AGENDA ITEM #5C

Council worksession to discuss the recommendations of the Planning, Housing, and Economic Development (PHED) Committee regarding the Planning Board Draft of the Forest Glen/Montgomery Hills Sector Plan.

SUBJECT: Forest Glen/Montgomery Hills Sector Plan—evaluation of transportation adequacy at buildout; transportation elements, evaluation of school adequacy at buildout, fiscal impact statement

SUBJECT: Forest Glen / Montgomery Hills Sector Plan
MCDOT Planning Board Draft Comments

Figure X: Signal Bypass in Rockville, MD

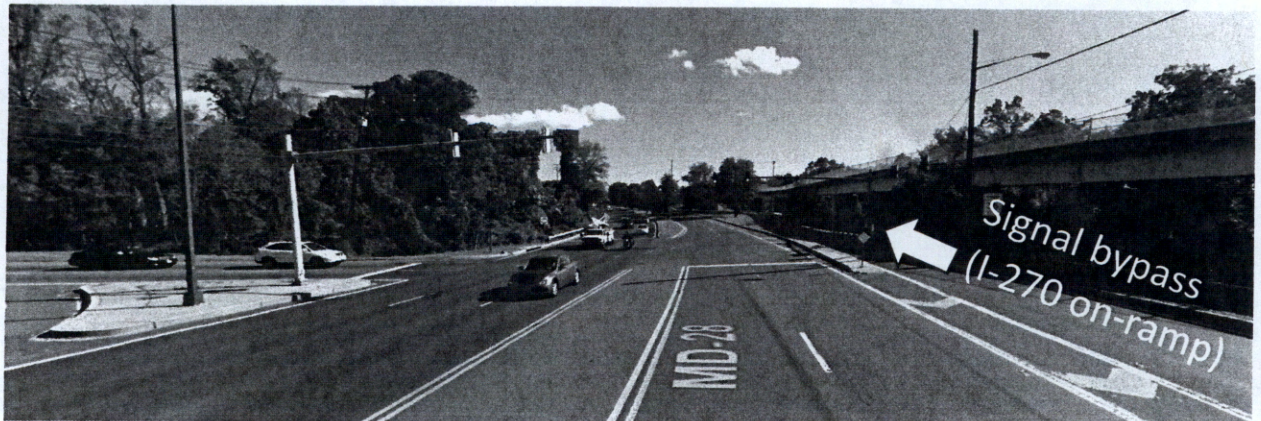
PHED Committee (and Council staff) recommendation (3-0): Include the Planning staff's recommended text to evaluate a northbound signal bypass ramp at the Georgia Avenue/Beltway interchange as part of the Short-Term Design Alternative. (See ©9.)

Another design treatment to consider and study further that would improve traffic flow, reduce queuing and increase safety is a channelized signal bypass for the two Beltway on-ramps, accessed from northbound Georgia Avenue. This treatment has been applied at other interchanges in the County. As an example, Figure X, shows the southbound I-270 on-ramp, accessed from eastbound Darnestown Road (MD 28).
